ACCEPTED  
J. DeGrood  
2/12/88

Hydrologic/Hydraulic Report  
for the Erosion Setback Limits  
of Lots 151-171 of  
Ventana Canyon Estates

Section 8, Township 13 South, Range 15 East  
OPW Job 82019-203

PROPOSED EROSION SETBACK LIMITS FOR LOT 158

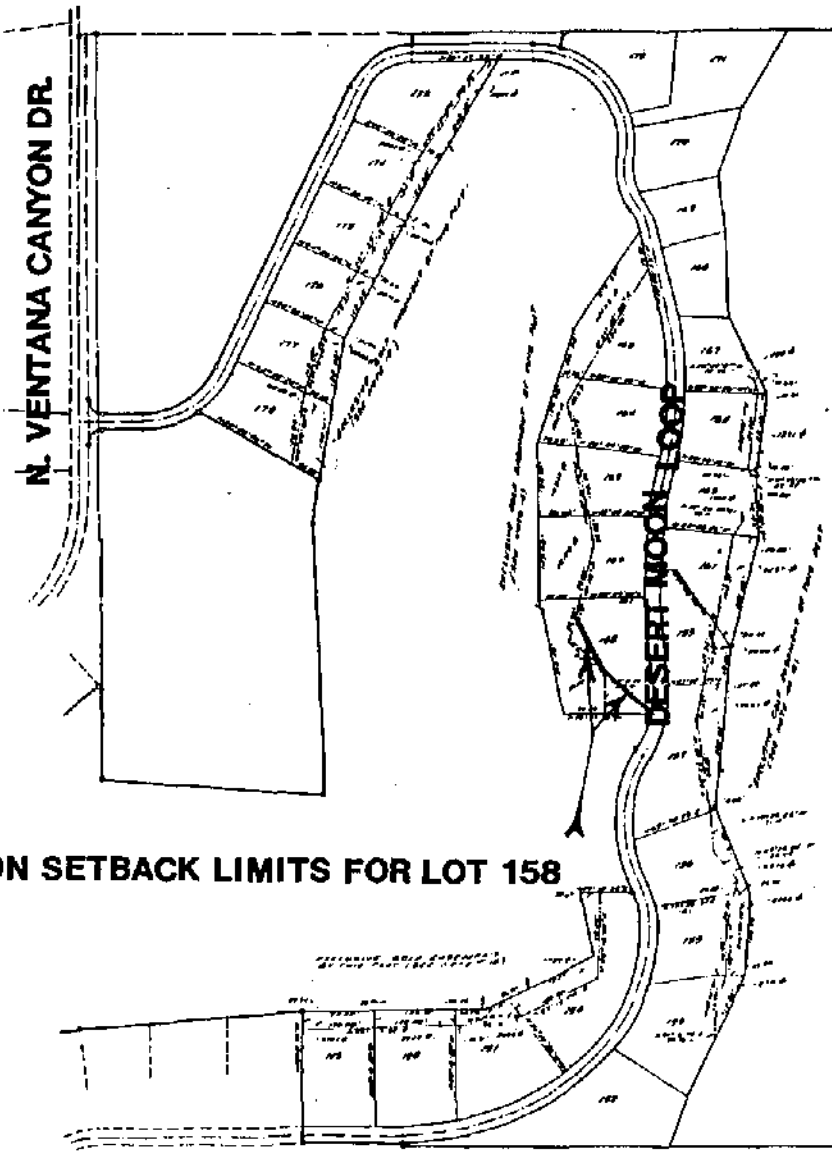
I MADE NO RECOMMENDATIONS  
AS TO LOCATION - I ASKED FOR A  
PROPOSAL JRD 2/12/88

Based on the observed conditions and anticipated development, we concur with the recommendations made by Mr. Jim DeGroot with Pima County Department of Transportation and Flood Control while on the site review. These recommendations were generally as follows. For lots 155 to 157 and lots 159 to 167 the erosion setback should be the existing golf course easement line. The erosion setback line should be a minimum of 10 feet from the 100 year flood line for lots 152 to 154. The erosion setback line for lot 158 should be about as shown on the attached site plan.
